CERTIFICATE OF APPROPRIATENESS

Property: Lot 12, Block 108, Norhill Neighborhood Subdivision. The property includes a historic 1,546 square foot, one-story wood single-family residence and detached garage situated on a 5,000 square foot (50' x 100') interior lot.

Proposal: Alteration of Previous Addition:

RENOVATION
 1131 PEDDIE STREET
 HOUSTON, TX 77008

2- PROPOSED SIDE (WEST) ELEVATION
1/4"

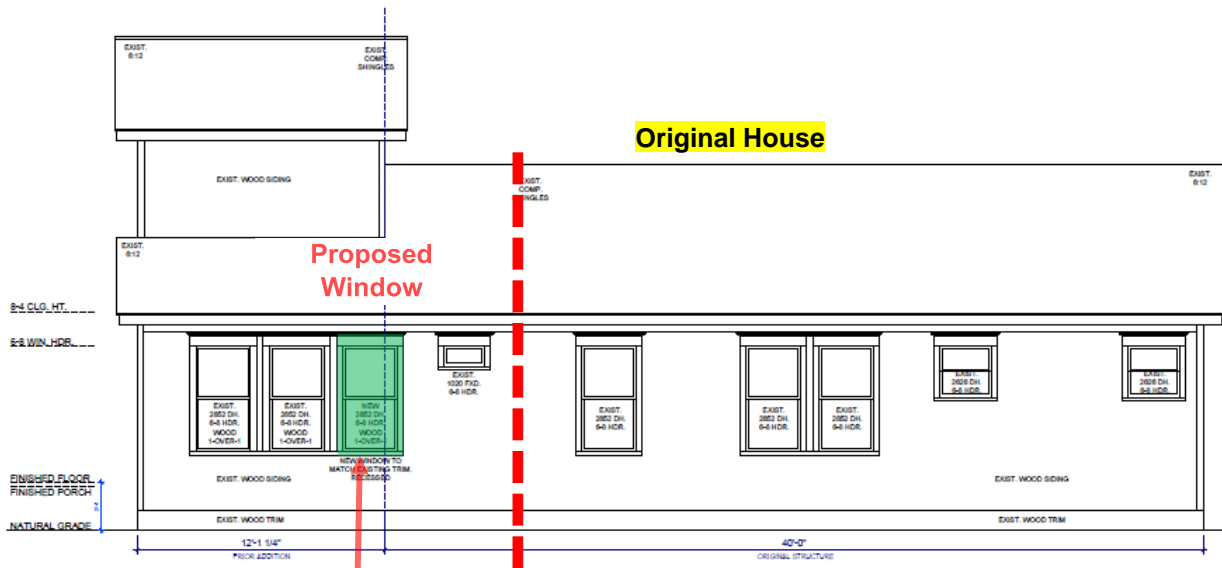
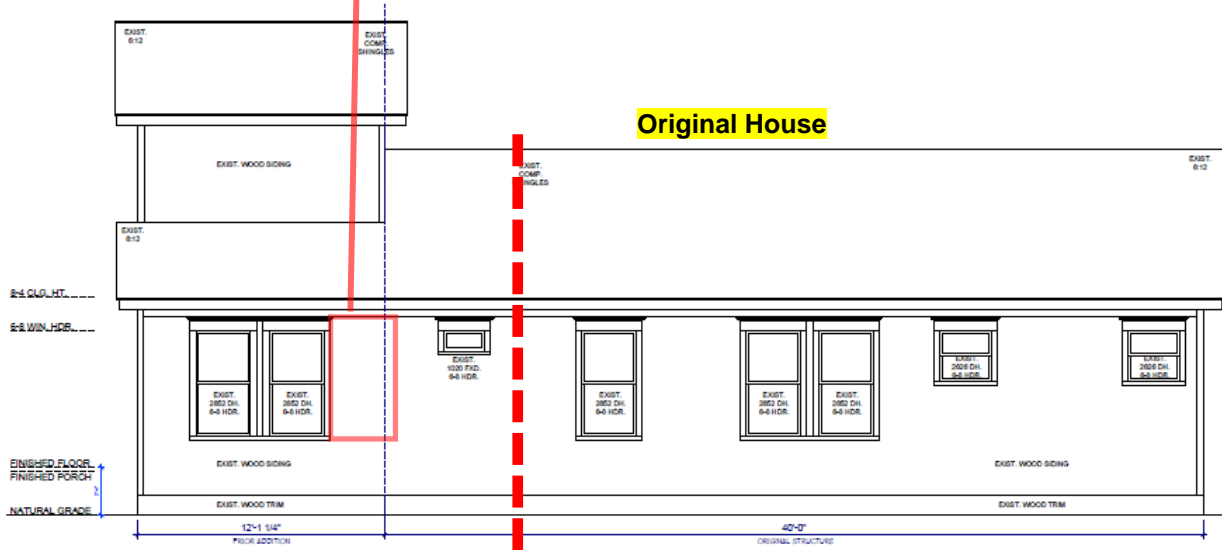
ALL NEW WINDOWS MUST BE INSET & RECESSED
ALL CEMENTITIOUS BOARD MUST BE SMOOTH

As we discussed recently, the NNA board voted during the Oct 10 board meeting to approve your project plans as submitted on Sep 29. Please note that when adding the third window in the ??? room, please make special effort to match the trim around this new window to match that of the adjacent windows to form a set of three windows that look as original as possible.

- New wood window, inset and recessed
- 2852 double hung next to two (2) existing 2852 double hung windows
- Trim of new window will match exterior trim of existing windows
